ADDENDUM TO THE CONTRACT
For
Wally Noerenberg Hatchery
Adult Collection System Improvements – Phase II Fishway Construction

ADDENDUM NO.: **One**

DATE ADDENDUM ISSUED: **October 3, 2017**

SHEET CONTENTS: LOWER FISH LADDER PLANS AND ELEVATIONS

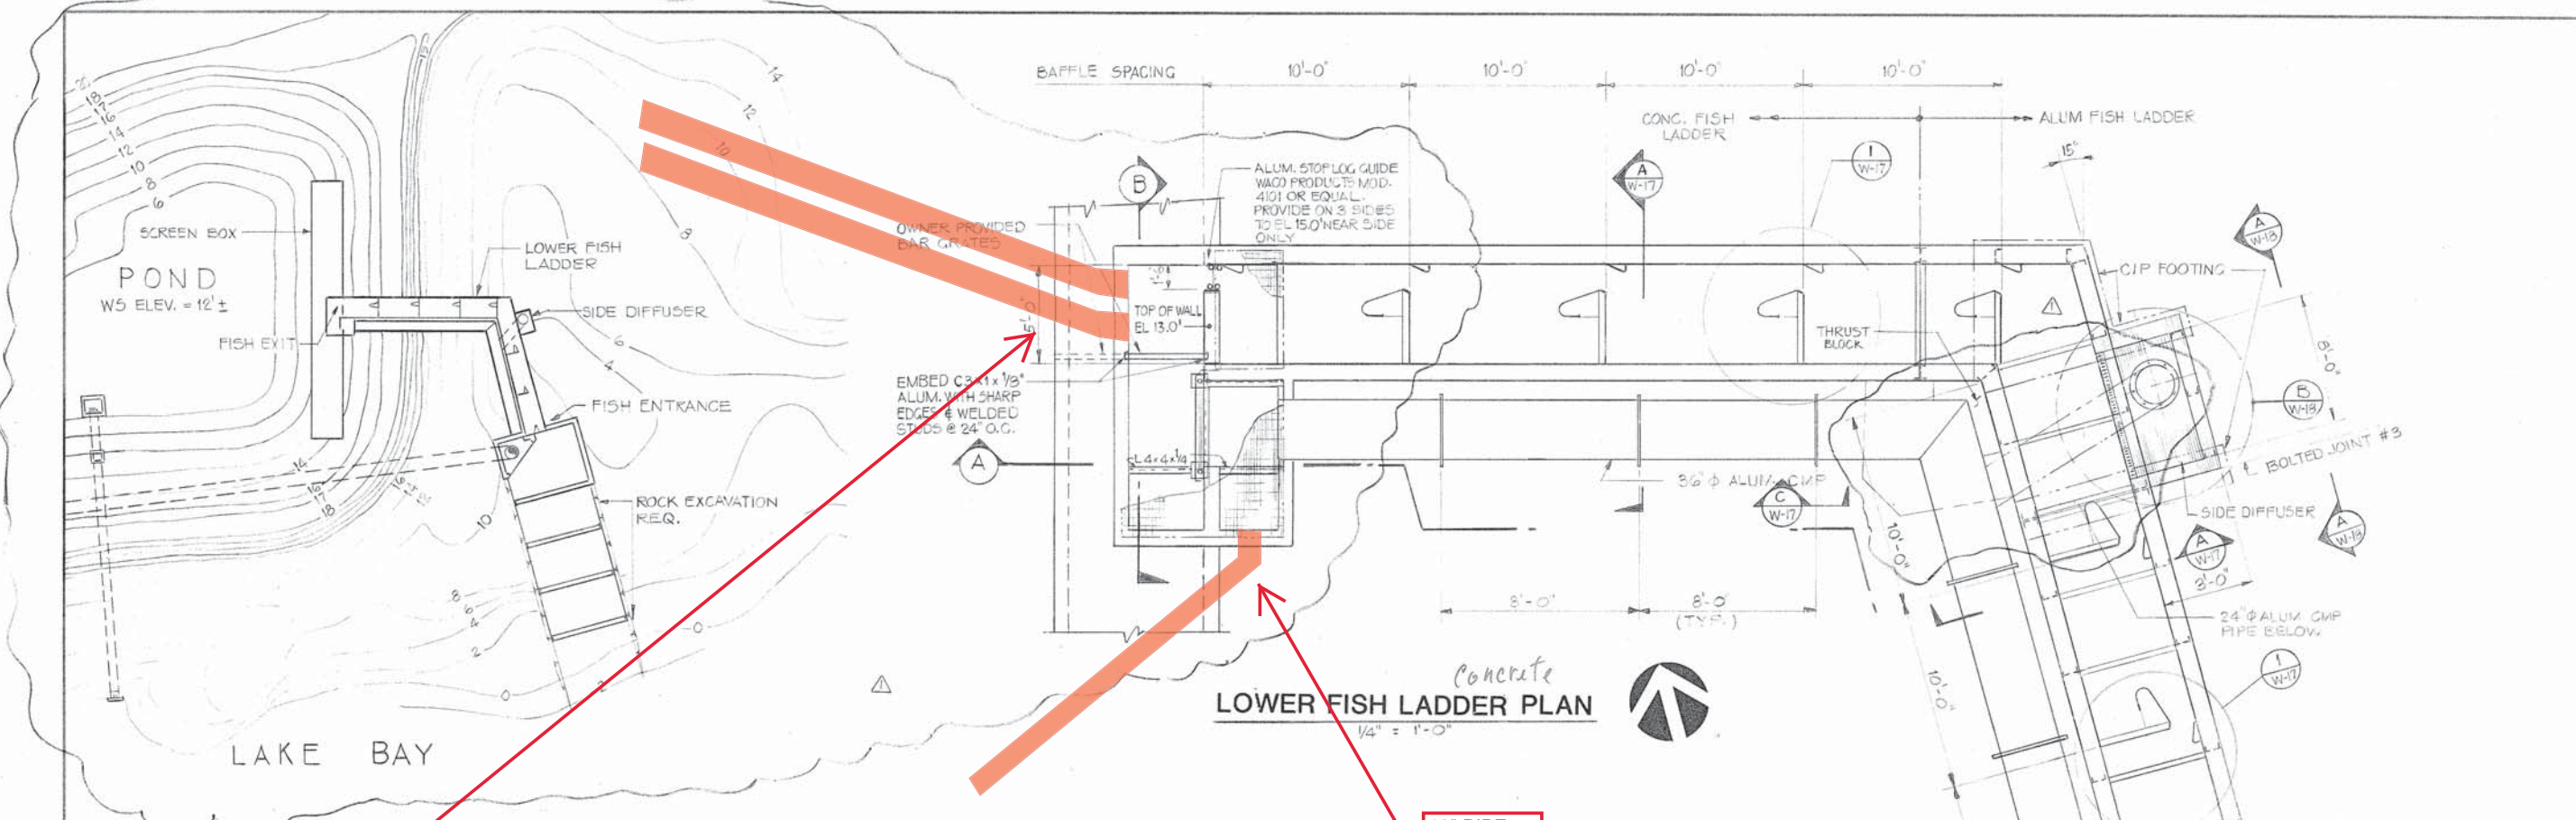
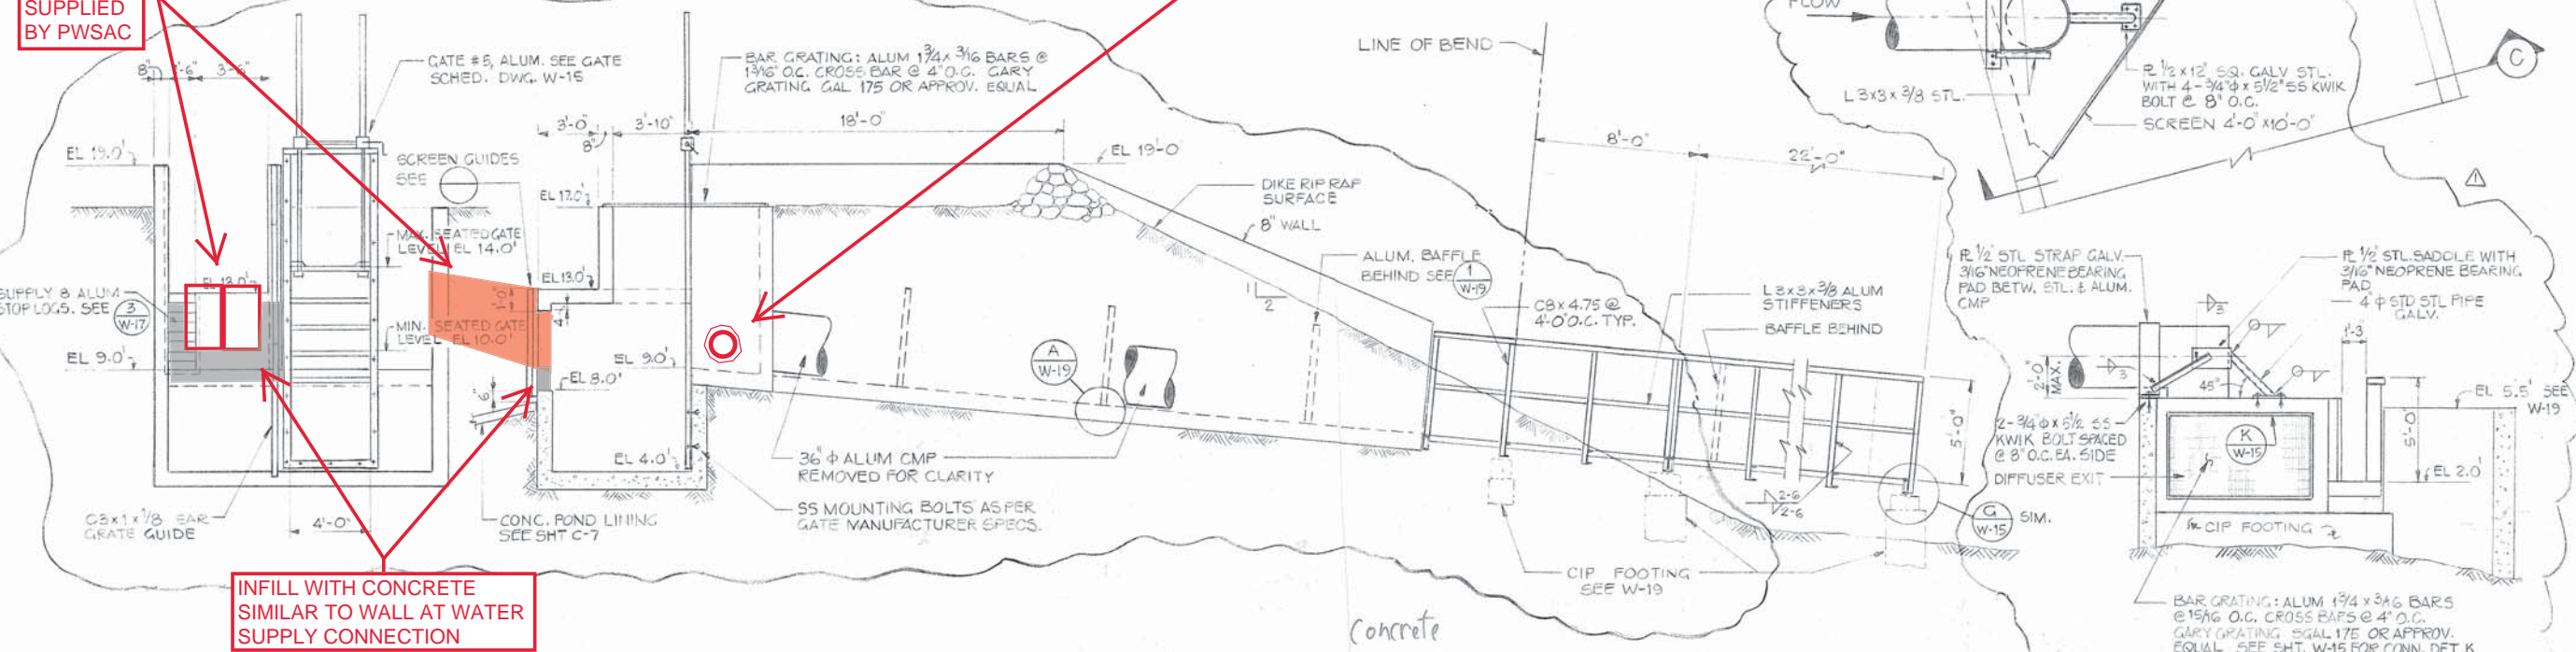
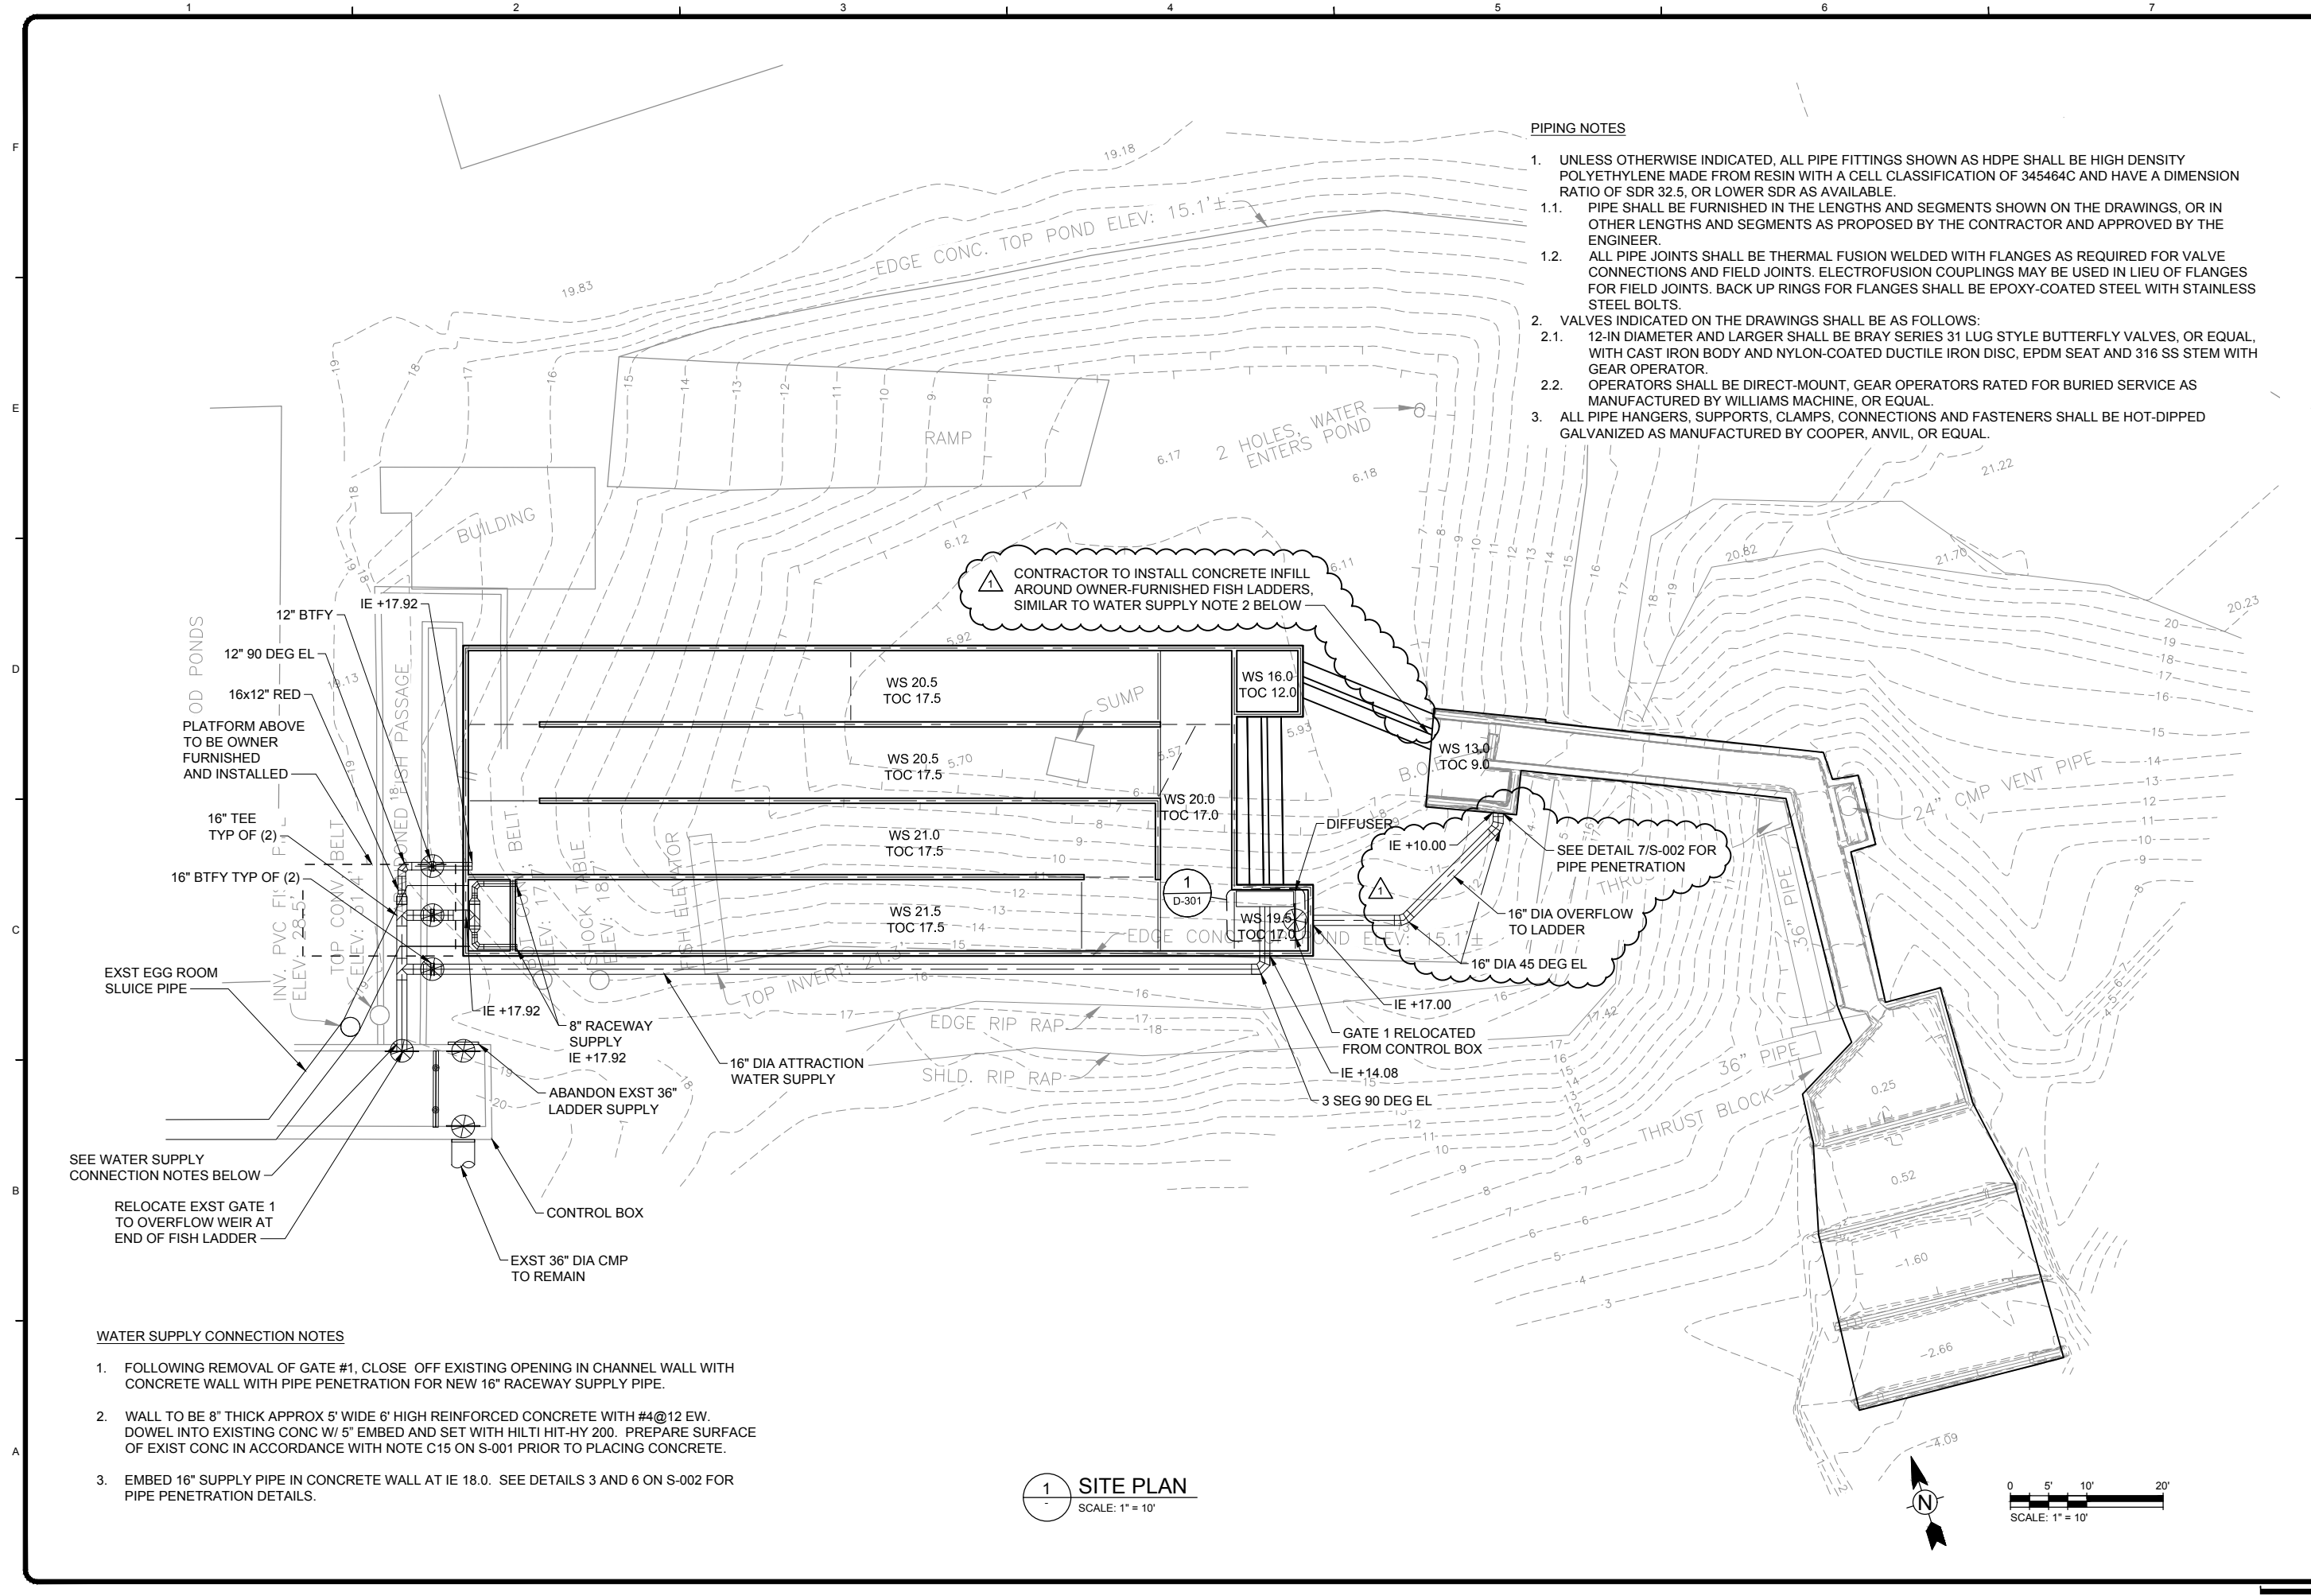
Item No. 1: Attached is a modified copy of Drawing W-16 from Esther Hatchery design drawings, dated 1985 illustrating the proposed connections to the existing lower fish ladder.

INFILL WITH CONCRETE
SIMILAR TO WALL AT WATER
SUPPLY CONNECTION

TYPICAL PIPE PENETRATION AT EXISTING CONCRETE

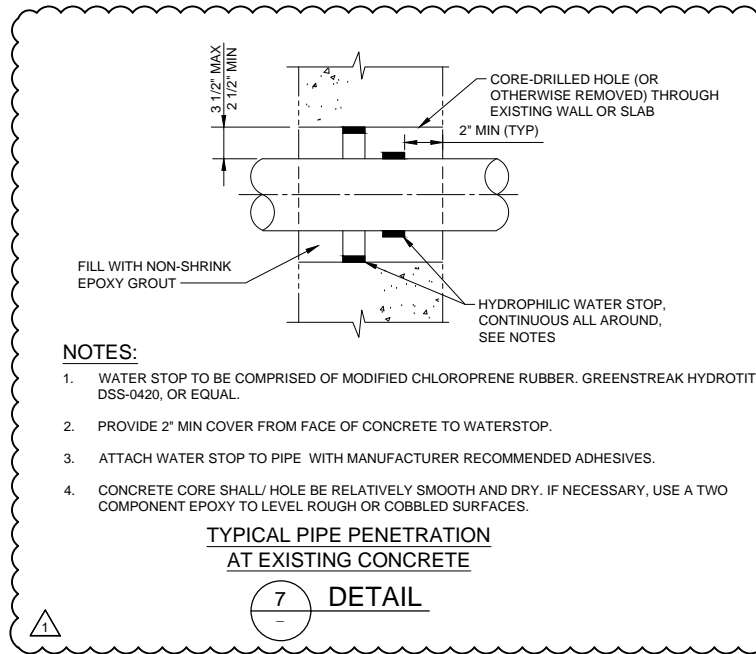
SEE DETAIL 7/S-002 FOR PIPE PENETRATION
16" DIA OVERFLOW TO LADDER
16" DIA 45 DEG EL

- WATER STOP TO BE COMPRISED OF MODIFIED CHLOROPRENE RUBBER. GREENSTREAK HYDROTITE DSS-0420, OR EQUAL.
- PROVIDE 2" MIN COVER FROM FACE OF CONCRETE TO WATERSTOP.
- ATTACH WATER STOP TO PIPE WITH MANUFACTURER RECOMMENDED ADHESIVES.
- CONCRETE CORE SHALL/ HOLE BE RELATIVELY SMOOTH AND DRY. IF NECESSARY, USE A TWO COMPONENT EPOXY TO LEVEL ROUGH OR COBBLED SURFACES.
